8747 Buckner Lane, Permit #F19-0006

Spann Addn., Lot 1R

Fence Review

FENCE PERMIT APPLICATION

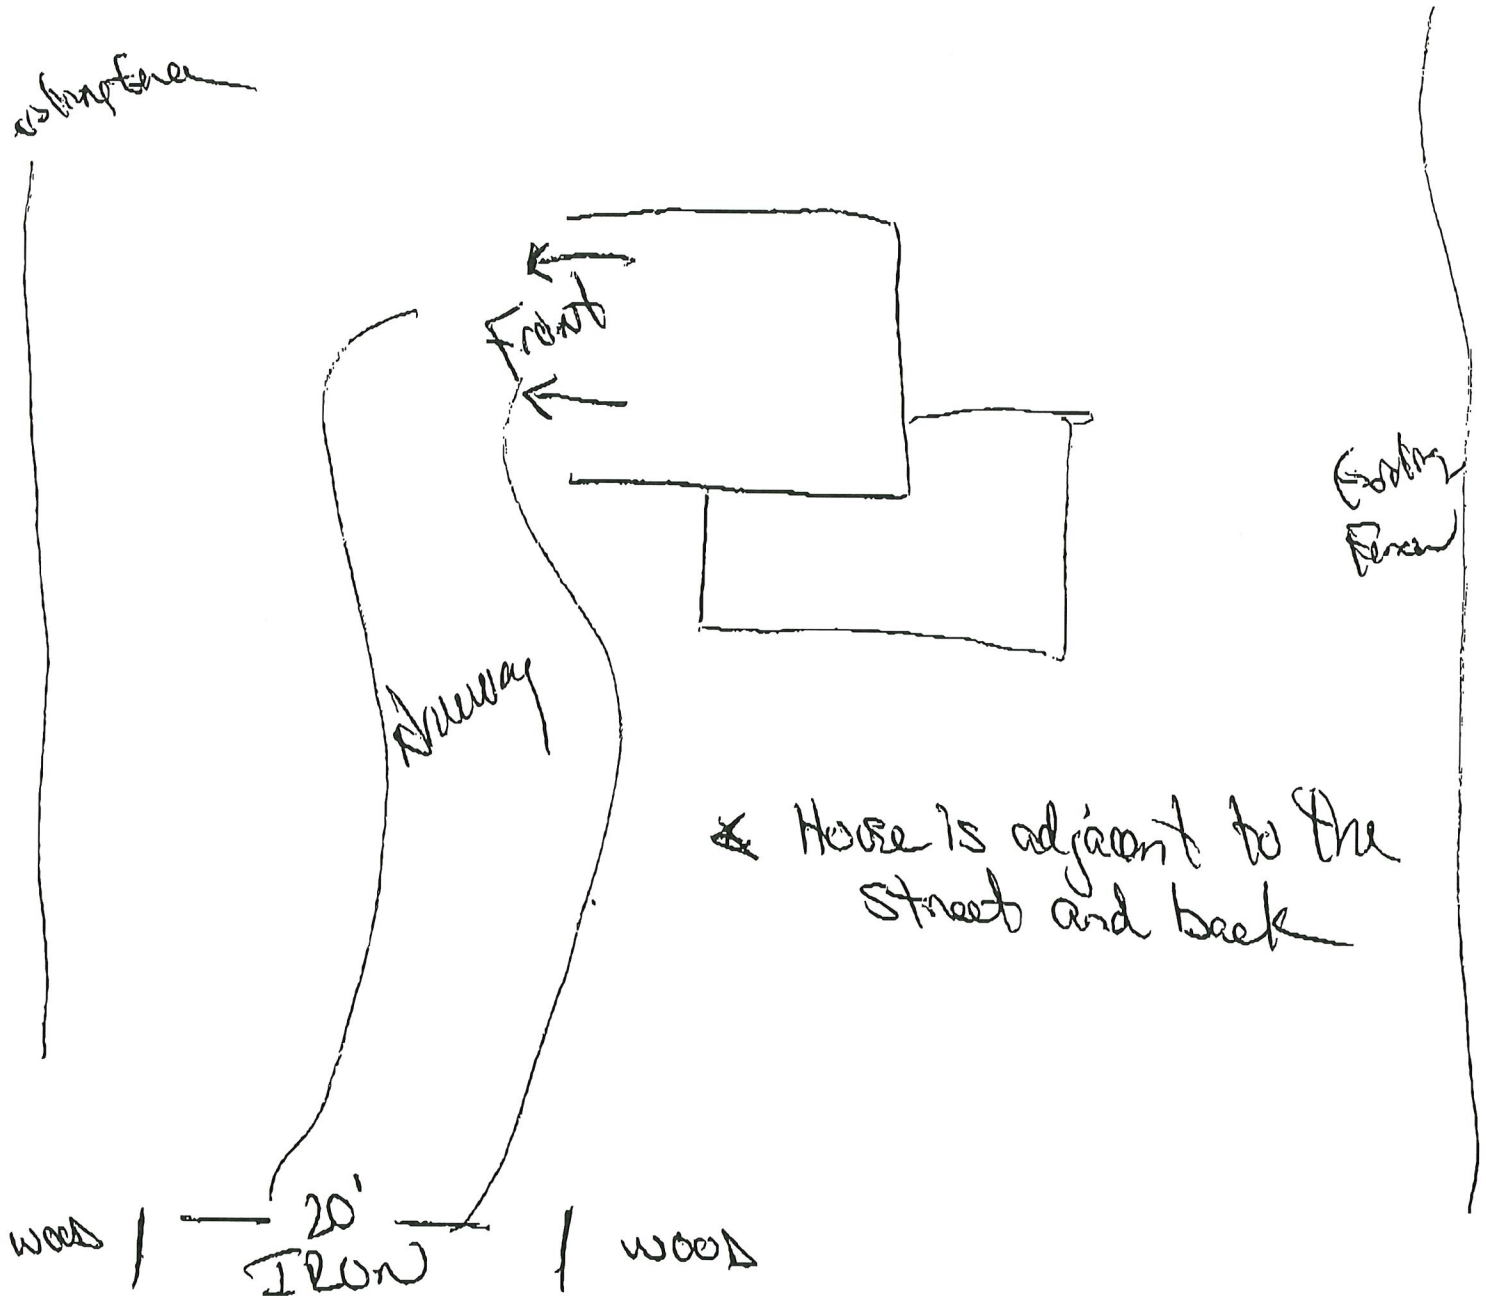
1. DENIED-No solid fencing over thirty-six inches (36") in height is allowed in front of the main structure. The fence has already been built by the contractor and must be remediated.

No solid fence over 36" is allowed in front of the main structure. Fence was already been built by contractor? must be remediated.
